WALLARAH 2 COAL PROJECT
RESPONSE TO LETTER FROM THE PLANNING ASSESSMENT COMMISSION
for
Wyong Areas Coal Joint Venture

Following its review of the documentation for the Project and the public hearing, the PAC provided a letter to Kores on 14 April 2014 seeking additional information regarding four issues:

The questions raised by the PAC in its letter dated 14 April 2014 are addressed in this document.

Baseflows to surface drainage catchments in subsidence area

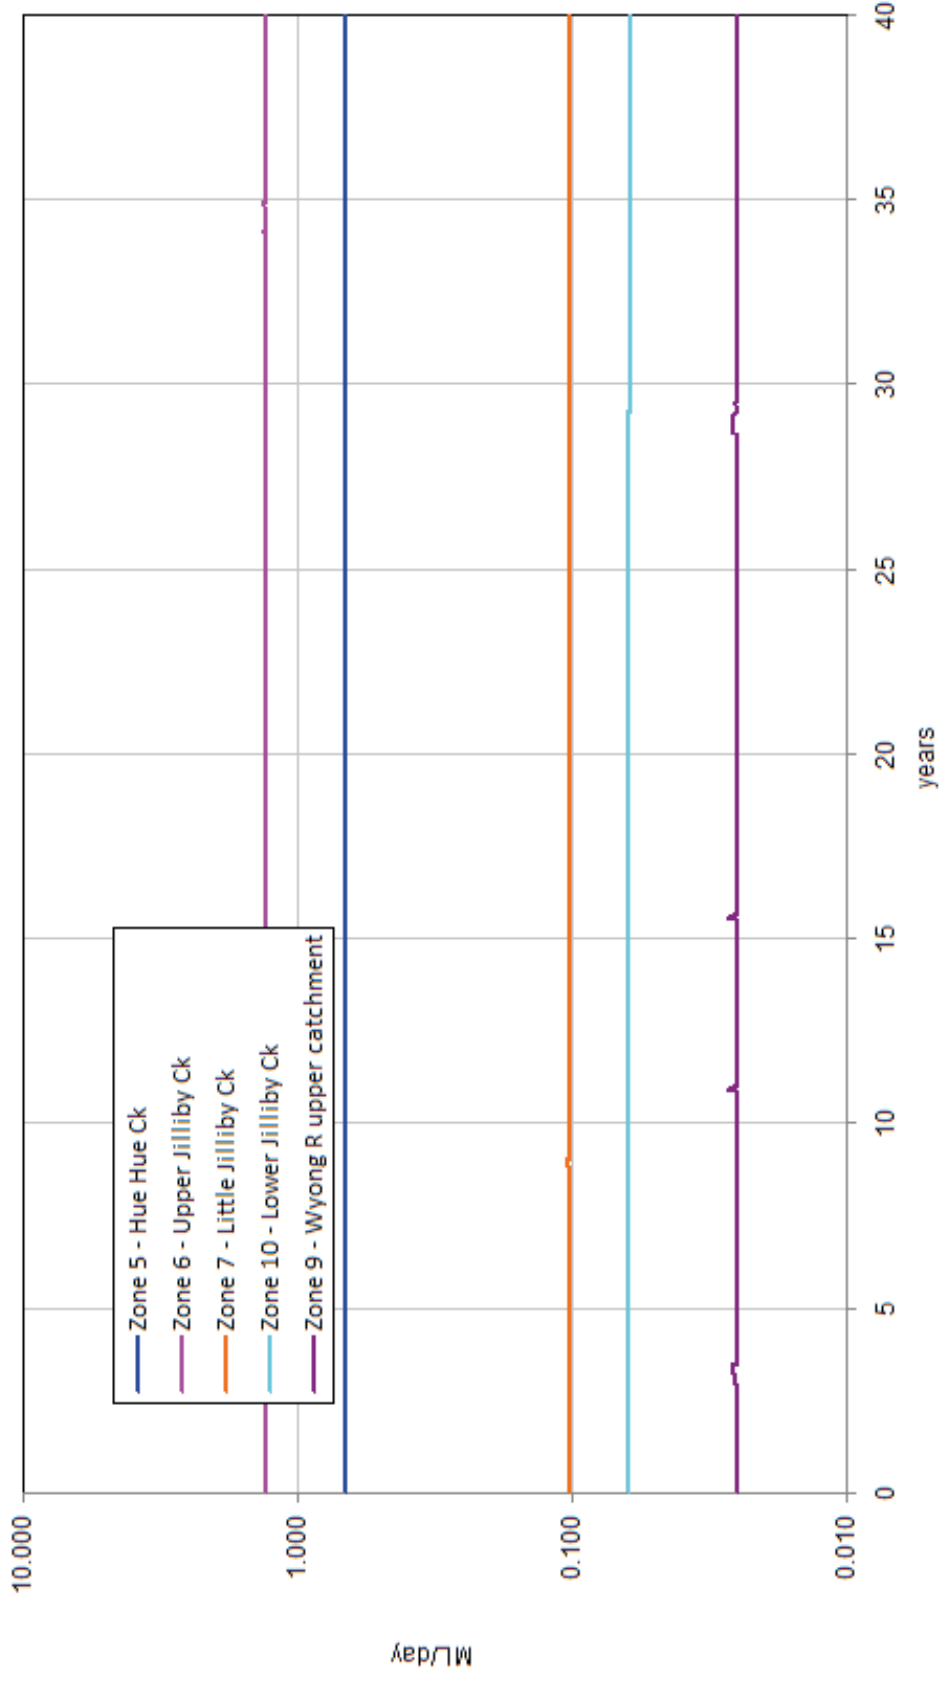
3. Does the Proponent accept that there will be an impact of the zone of depressurisation of the mine on the baseflow to the streams supplying the GWWSS (a) during mining or (b) at any time in the future? If the answer to either (a) or (b) is positive, can the Proponent please provide details of the likely impact and when it might occur?

Since the water supply scheme does not harvest any water from the groundwater systems in the vicinity of the Project, there is only the potential for impacts on the water supply if the groundwater impacts affect stream flow. The groundwater model predicts no measurable reduction in baseflow (see **Figure 2**).

Change in Stream Bed Gradient due to Subsidence

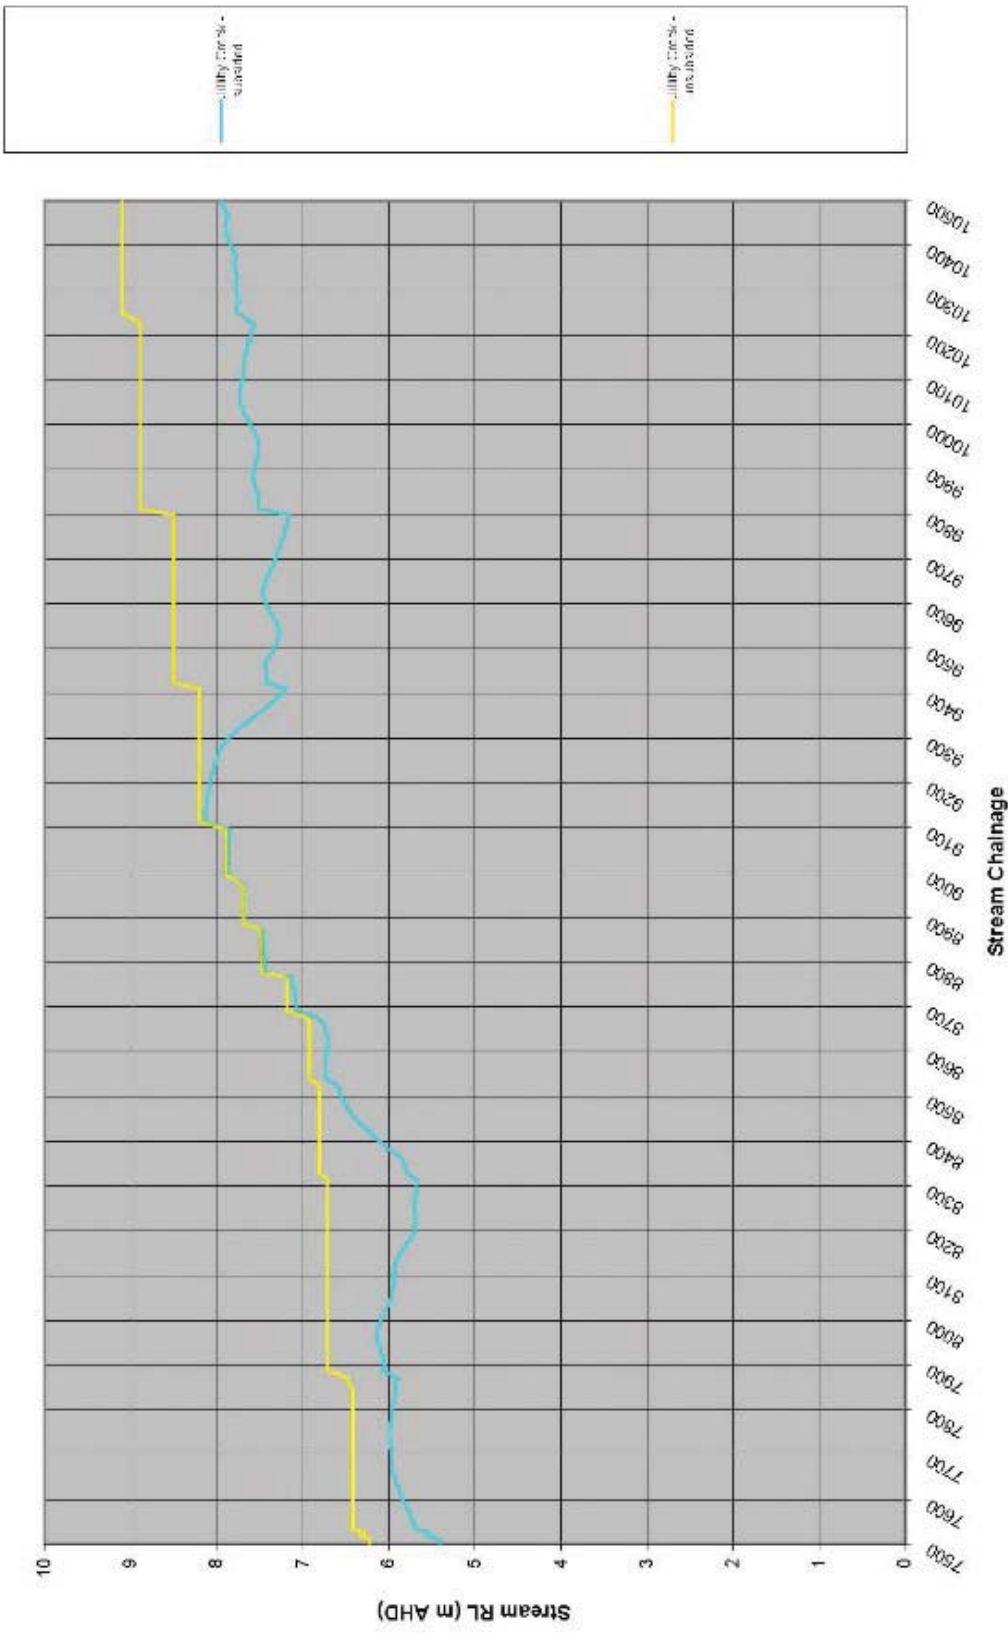
What is required is a performance measure (or measures) that require the predictions not to be exceeded at all points along the streams and then require the Proponent to prevent adverse consequences (i.e. headcuts, bank erosion, etc.) in the areas of risk. In this context the Commission notes that changes in gradient as individual longwalls impact the stream will be much greater than the average change in gradient along the stream once subsidence stabilises.

Approximately 6 km of the Jilliby Jilliby Creek main channel upstream of its confluence with Little Jilliby Jilliby Creek is expected to be subsided. The maximum subsidence along this reach is predicted to be 1,400 mm. An additional 1 km of the main channel downstream of the confluence is predicted to experience subsidence of up to 1,000 mm. At Area 1 (see **Figure 10**), there is predicted to be a “drop” in the channel of approximately 600 mm as the channel passes from unsubsidised to subsidised areas, resulting in a steepening of the average bed gradient. At Area 3, there is predicted to be a “rise” in the channel of approximately 400 mm as the main channel passes from subsidised to unsubsidised areas. This results in a flattening of the average stream bed gradient. The changes in gradient at Areas 1 and 3 are illustrated in **Figure 11**.

Figure 11 and **Figure 12** both use significant vertical exaggeration to clearly illustrate the changes in gradient. Consequently, the actual changes in gradient are not as pronounced as they appear in these figures.

FIGURE 13

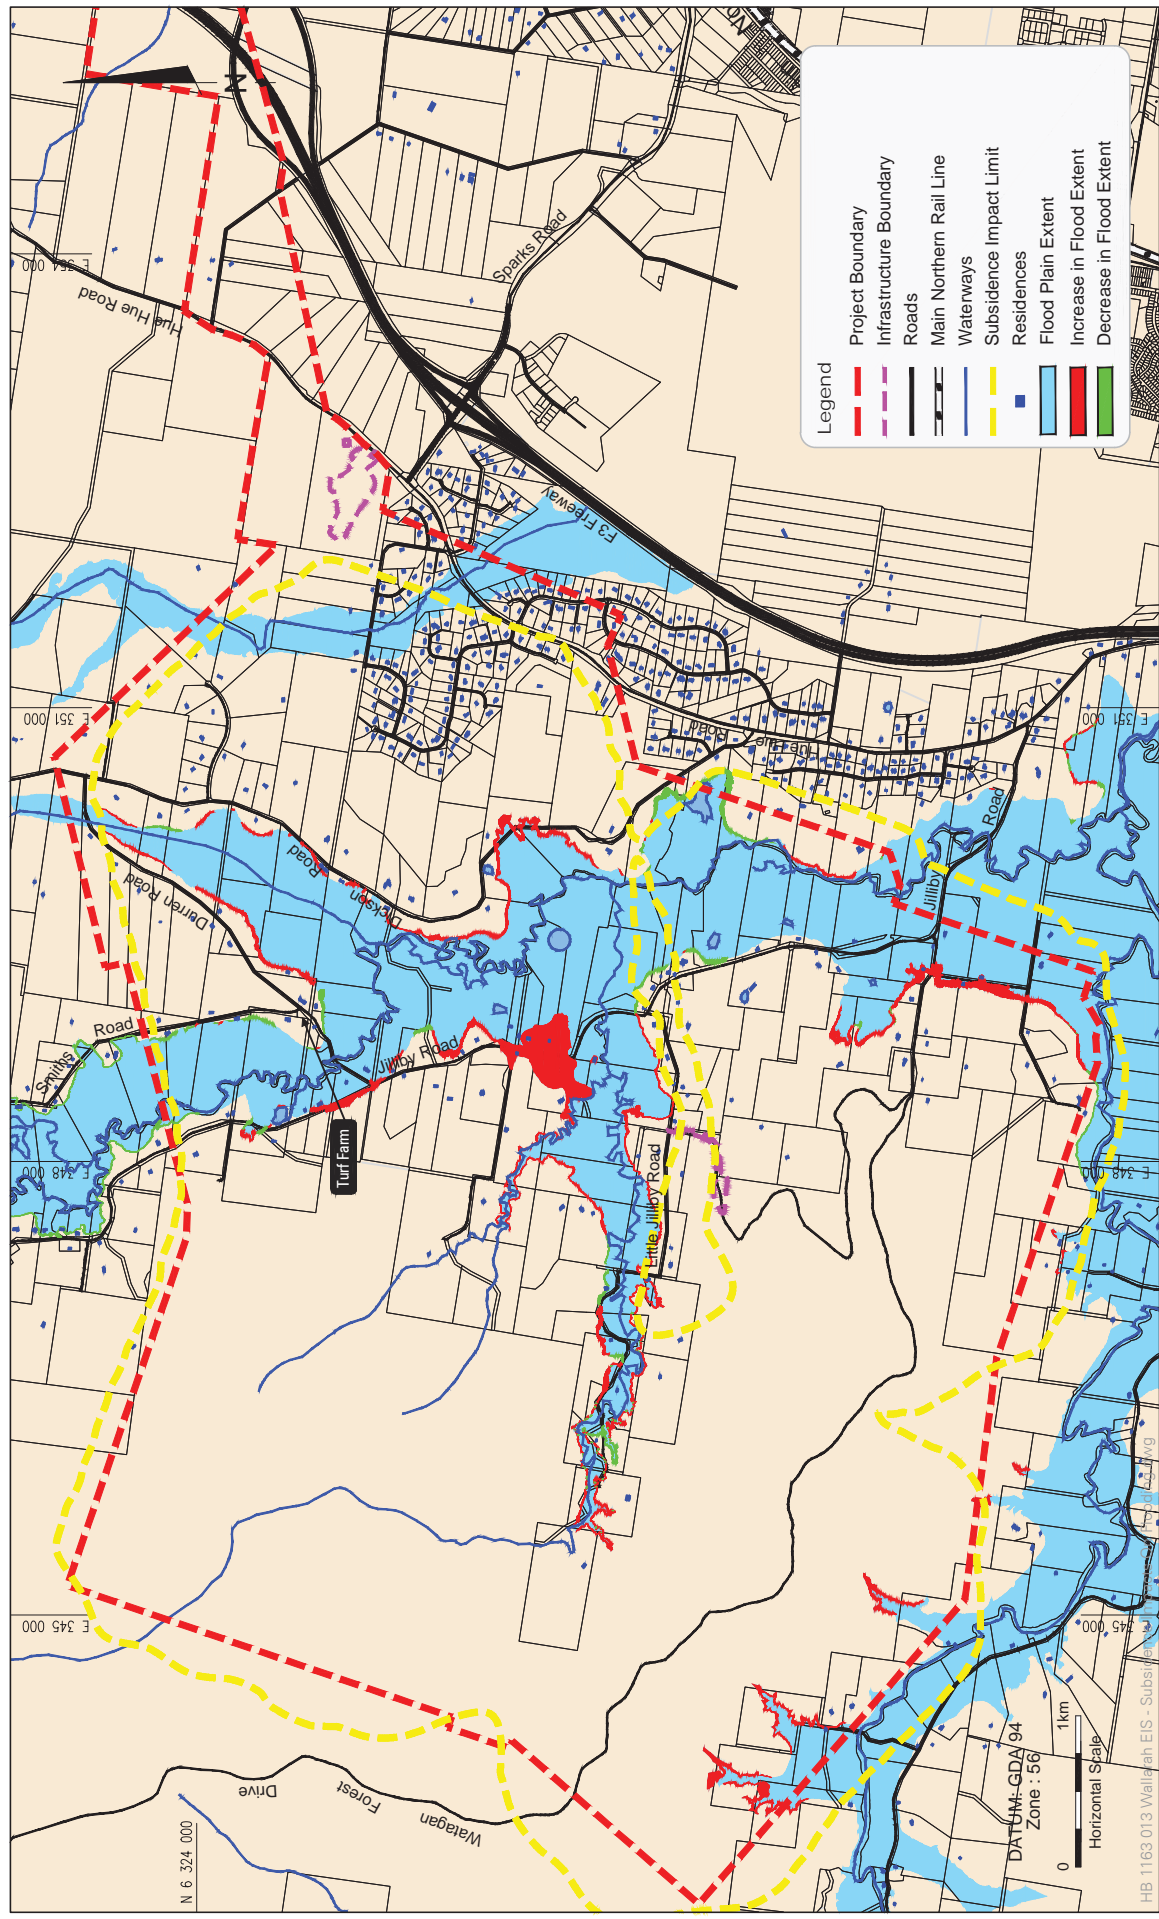
- (i) that uncertainties associated with use of a yielding pillar mine design in the Project Area geology may mean that surface deformation is not as predicted (either in extent or timeframe). What flood studies have been done that incorporate potential variations in surface topography resulting from possible variations in pillar behaviour? What are the potential consequences compared to those predicted?
- (ii) While compensation, modifications, etc., are proposed for potential impacts on existing residences, etc., what is proposed for situations where there is increased risk of flooding on land that would have been suitable for development (e.g. subdivision)? How many properties are in this category (details please)?

The increase in flood extent due to subsidence is shown in **Figure 13**. There are only four properties that will experience a significant increase in the property area that will become inundated during a 1% AEP flood. These properties are located near the intersection of Jilliby Road and Beavers Lane. A number of other properties are expected to experience minor increases in the property area that will become inundated during a 1% AEP flood.

There are no commercial enterprises located within the area that is currently not flood prone, but will become flood prone after subsidence. There is one active turf farm located on Durren Road (see **Figure 13**) that is currently within the 1% AEP flood extent. This turf farm has an operational area of approximately 40 ha and undergoes two harvesting periods per year. This farm will experience more frequent flooding and for slightly greater durations.
